SUBJECT: AMENDMENT NOS. 146 AND 133 TO FACILITY OPERATING LICENSE NOS. DPR-58
AND DPR-74: (TAC NO. 76650)

DONALD C. COOK NUCLEAR PLANT, UNIT NO. 1

Amendment No. 146
License No. DPR-58

SAFETY EVALUATION BY THE OFFICE OF NUCLEAR REACTOR REGULATION
RELATED TO AMENDMENT NO. 146 TO FACILITY OPERATING LICENSE NO. DPR-58
AND AMENDMENT NO. 133 TO FACILITY OPERATING LICENSE NO. DPR-74

FIGURE 3.1-2

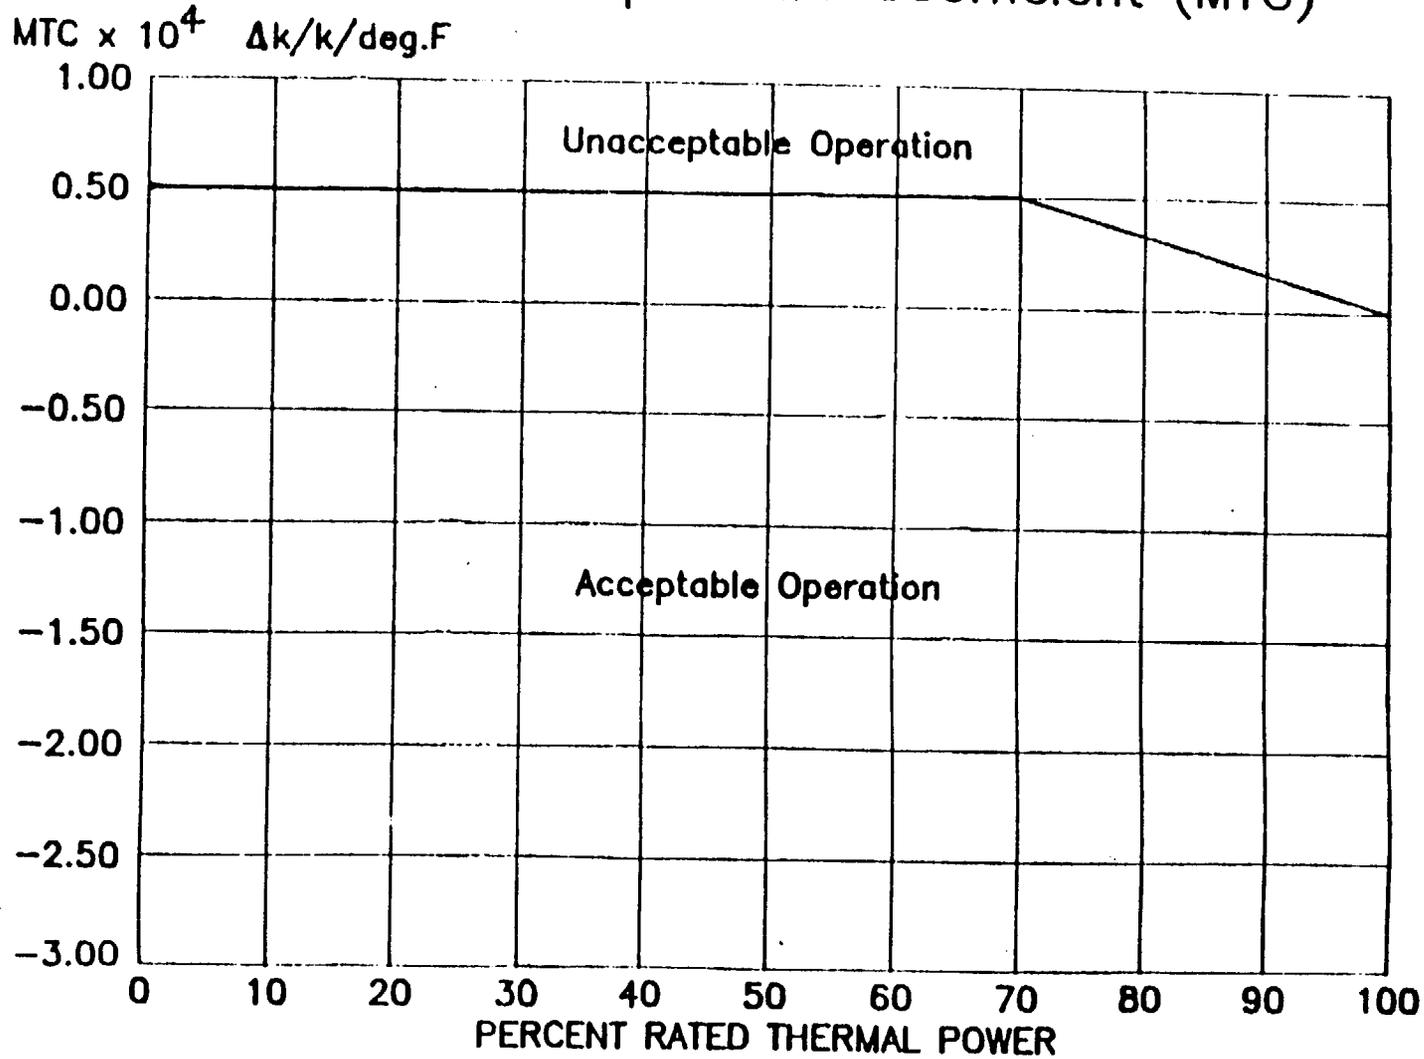
3.1.1.4 The moderator temperature coefficient (MTC) shall be within the limits specified in the COLR. The maximum upper limit shall be less than or equal to the limit shown in Figure 3.1-2.
